UNITED STATES PATENT AND TRADEMARK OFFICE

APPLICATION NO.	FILING DATE	FIRST NAMED INVENTOR	ATTORNEY DOCKET NO.	CONFIRMATION NO.
09/652,998	08/31/2000	D. Mark Durcan	98-1068.06	4016

Office Action Summary

DETAILED ACTION

FIG. 12

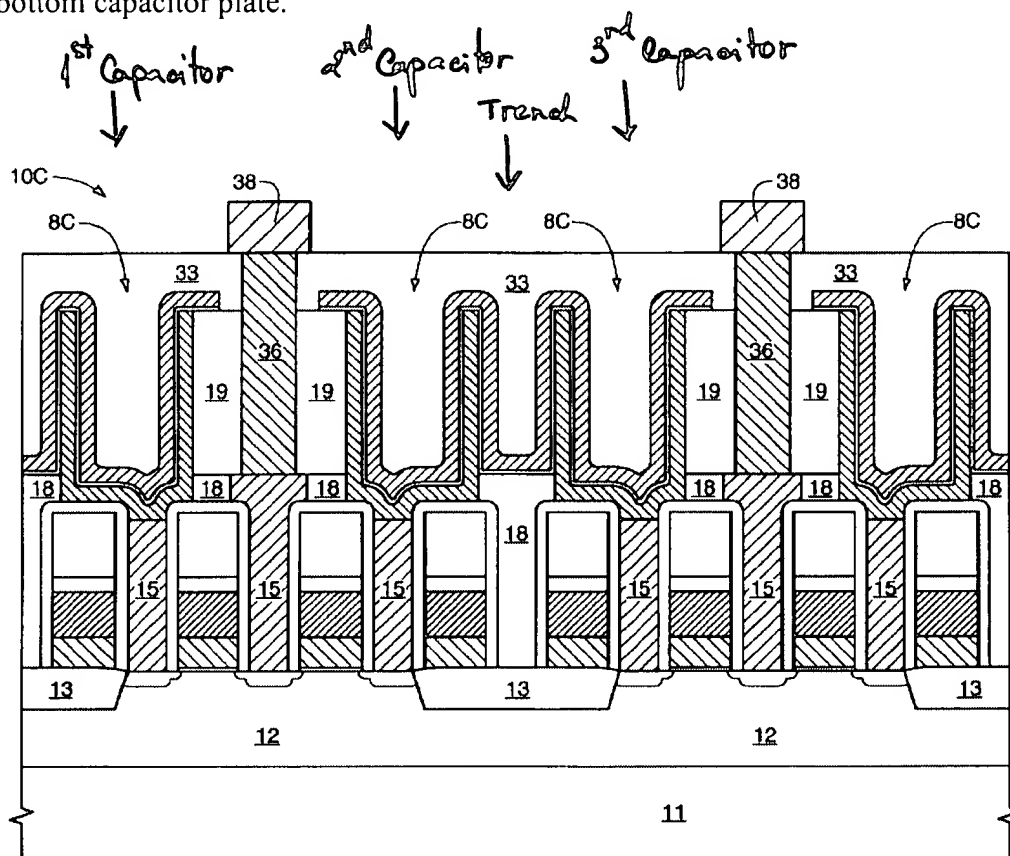
As shown in Fig. 12, the top capacitor plate 24c lining the trench between the second and third bottom capacitor plates (middle of the drawing). Clearly, the top capacitor plate 24C is vertically descent between the second and third bottom capacitor plates. (See below).

As best understood by the examiner, the top capacitor plate is vertically descent between each of the second and third bottom capacitor plates but does not descent between the first and second bottom capacitor plate.

Note that, the trench is locate between the second the third bottom capacitor plates (lines 8-9). (See Fig. 12 above).

How can top capacitor plate lining the side (vertically descent) of the trench be characterized as does not vertically descent ?

FIG. 10

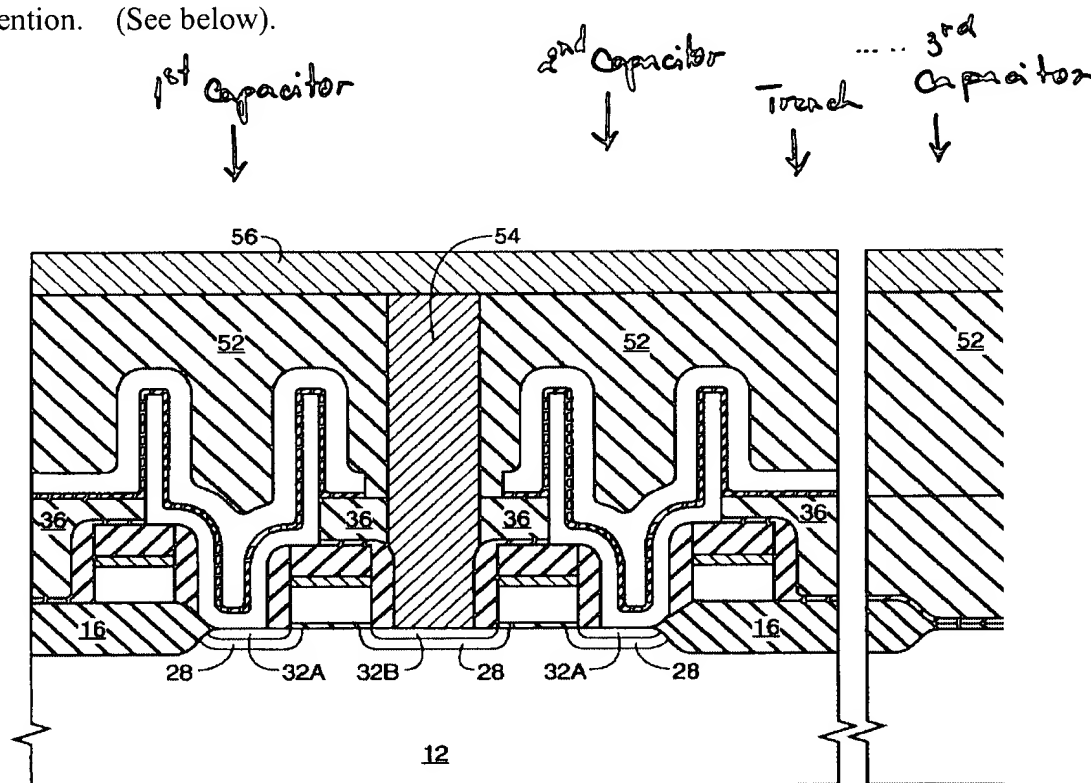
a dielectric (46) between the top capacitor plate (50) and the first, second, and third bottom capacitor plates (44). (See Fig. 10).

Thus, Becker is shown to teach all the features of the claim with the exception of the top capacitor plate (50) does not vertically descent between the contact.

With respect to the third bottom capacitor plate (44), although Becker does not show a third bottom capacitor plate (44) in the drawing, however, one having ordinary skill in the art should recognize that the third bottom capacitor plate is actually the first bottom capacitor plate of the adjacent cell, on the outside (left and right) of the first and second bottom capacitor plates (44) since the capacitors of Becker are formed in an array, as shown in Fig. 1 (prior art) of the present invention. (See below).
